TCEQ SCS MOD APPLICATION

SANTA RITA RANCH PHASE 7B SECTION 4
WILLIAMSON COUNTY, TEXAS

CBD No. 5488
August 2025

WWLN "B"
12" SDR-26 PVC STA. 0+00 TO 3+17.49 - 8" SDR-26 PVC STA. 3+17.49 TO 6+00

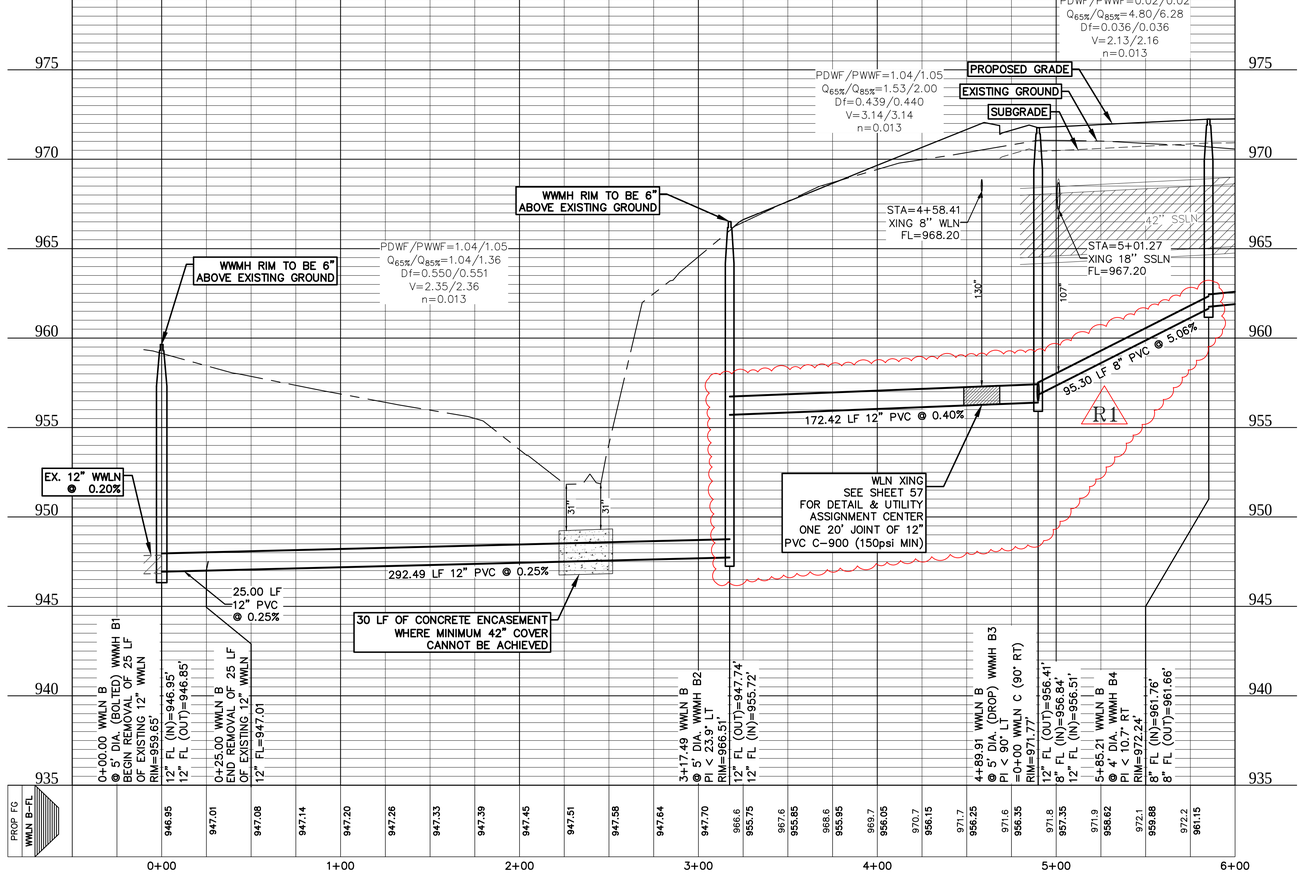
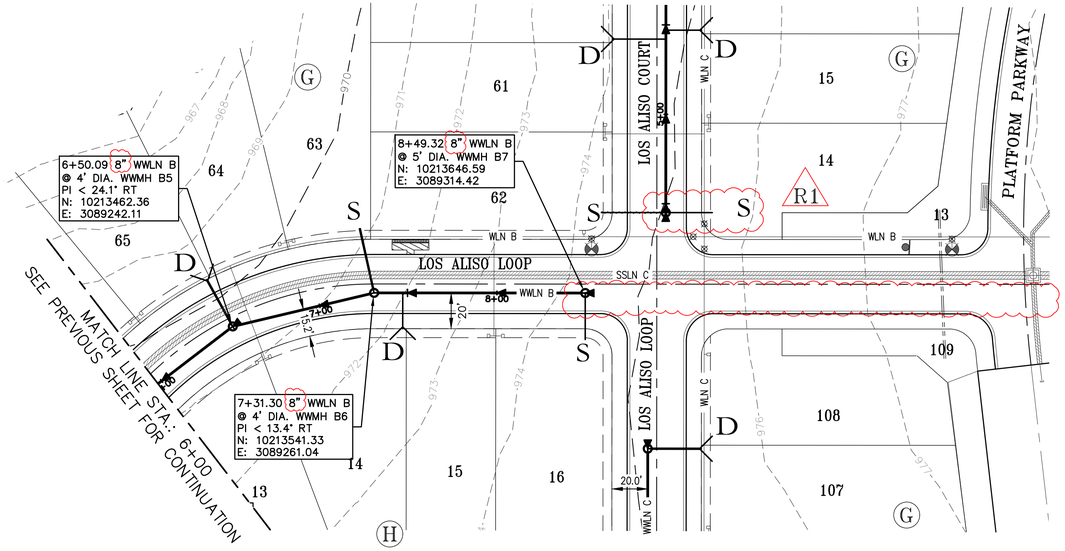
FILE PATH: J:\ACD\5488\dwg\5488 WASTEWATER.dwg - May 26, 2025 - 3:03pm
